# Proposal for amendments to ECE/TRANS/WP.29/GRSP/2011/14 (Draft 01 series amendments to draft Regulation on pedestrian safety)

Note: This document was prepared by the expert from Japan in order to conduct Technical/Editorial amendments. The amendments are supported by Flex-TEG members.

"Figure 5

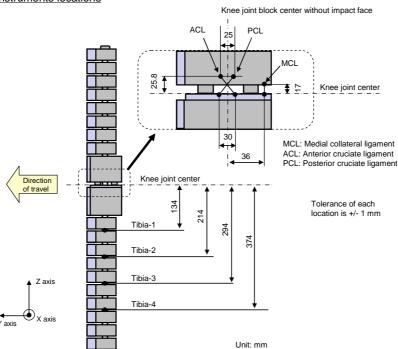
Figure 5 of Annex 4., amend to read:

Figure 5 of Annex 4., Indicated locations are amended (editorial):

#### "Figure 5:

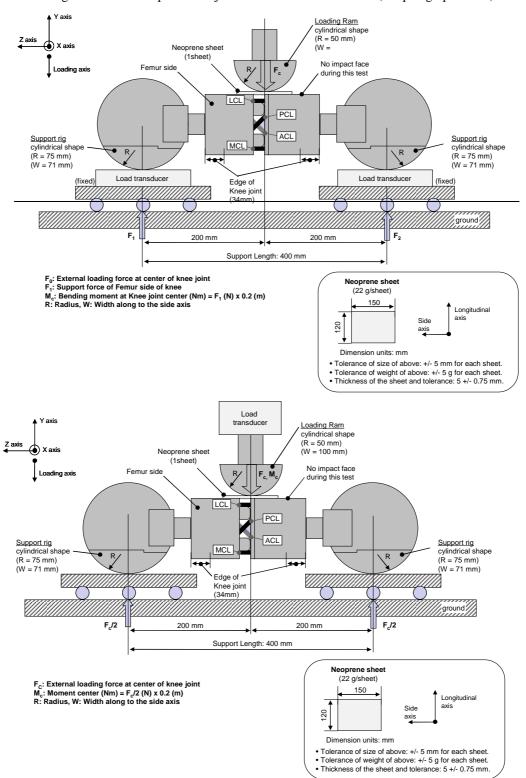
Figure 5 of Annex 6., amend to read:

Figure 5 of Annex 6., Load transducer positions and comments are amended/updated (technical):
